MAM*25/35/45/55 Series Bracket Change Notification

MAM*25/35/45/55 series

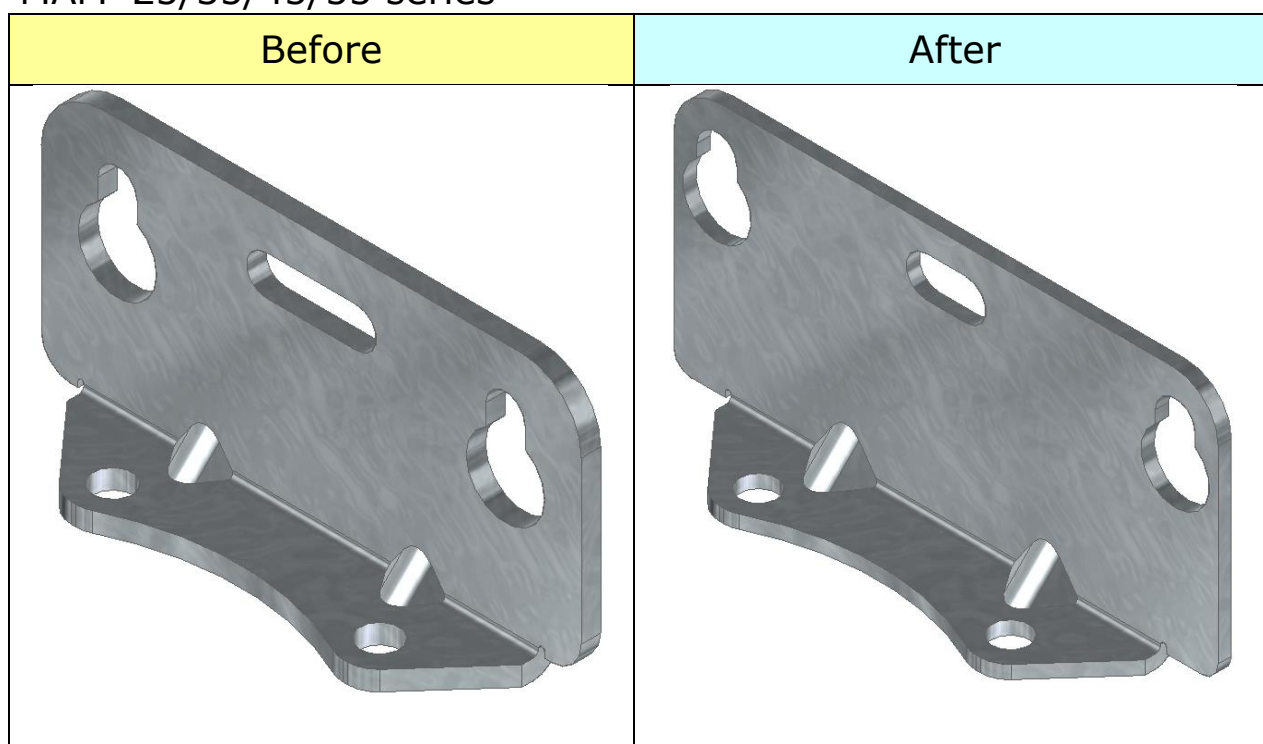
In response to market demand, the bracket distance from the body and the pitch of hole will be modified.
